Construction Division
Additions & Alteration Charges Approval Form

Company Name:	MRMLLP	Site	Gulmohar Residency
Name of the customer	S. Krishan		
Villa/ Flat No.	D - 30.7

Details of Additions & Alterations

Flat No	307	Block no.	' D '
Flat Area	1660 sft	Type	Deluxe / Luxury
Buyer Name	S Krishnan		
Phone No.	9989709470 800 8052479	Email	Sivkrish 76@gmail.com

Changes in flooring:

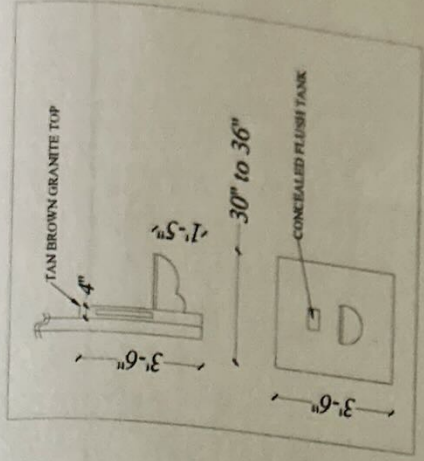
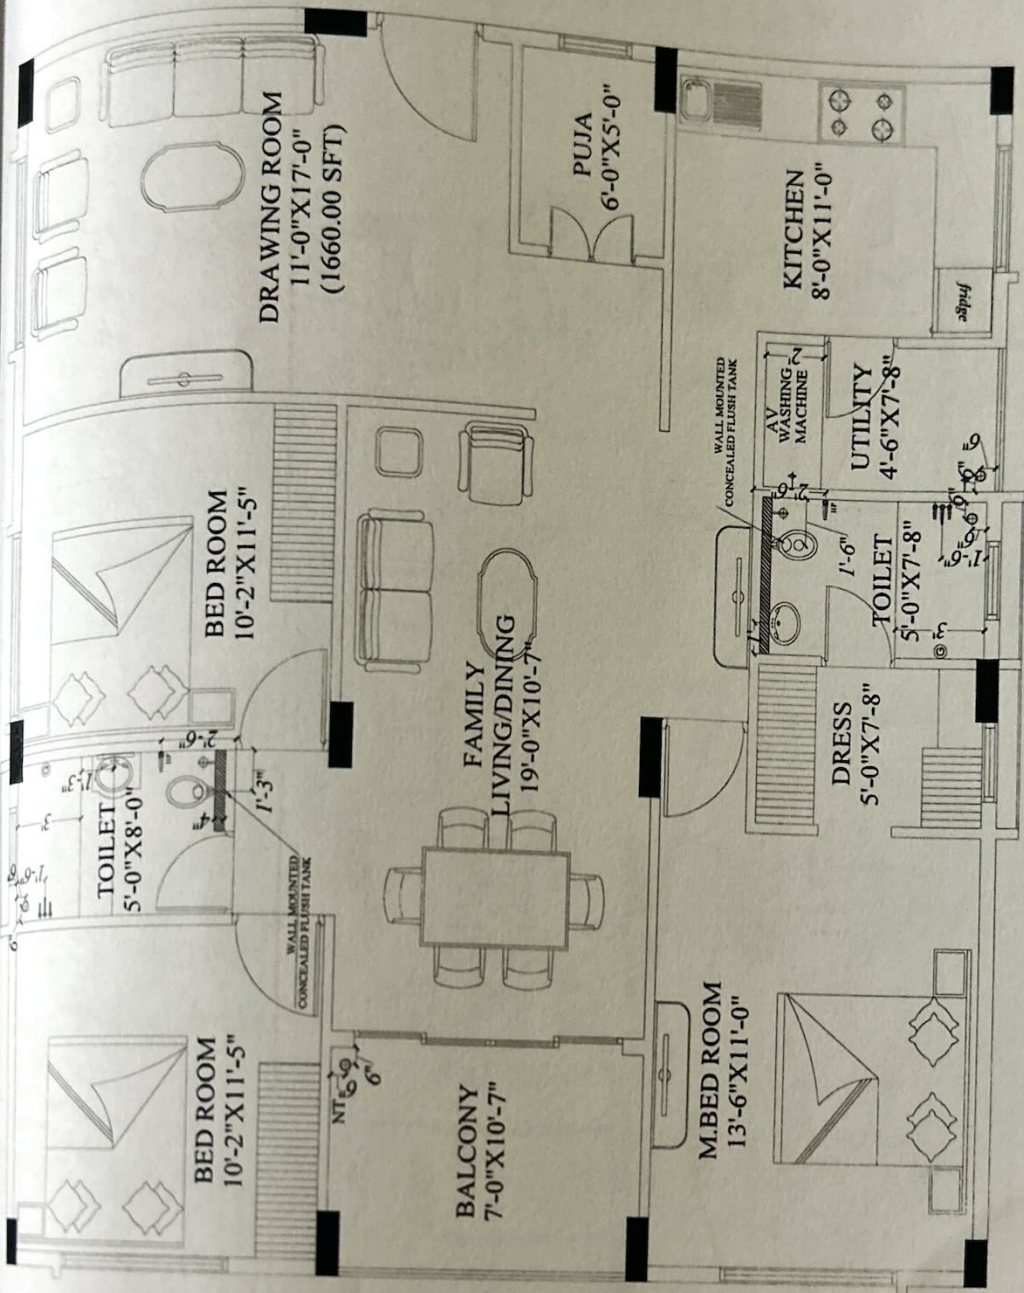
- 1) Master toilet - Luna series
- 2) Common toilet - ultra sprinkle
- 3) Utility - flooring - country Almond & wall
- 4) Kitchen Dado - ~~Bamboo~~ ~~white~~ as per model flat. Dado tiles
Kitchen
tiles
- 5) Flooring Dining & Drawing: - Stained concrete Beige
- 6) All Bed rooms - Urban wood natural. ~~Bamboo~~
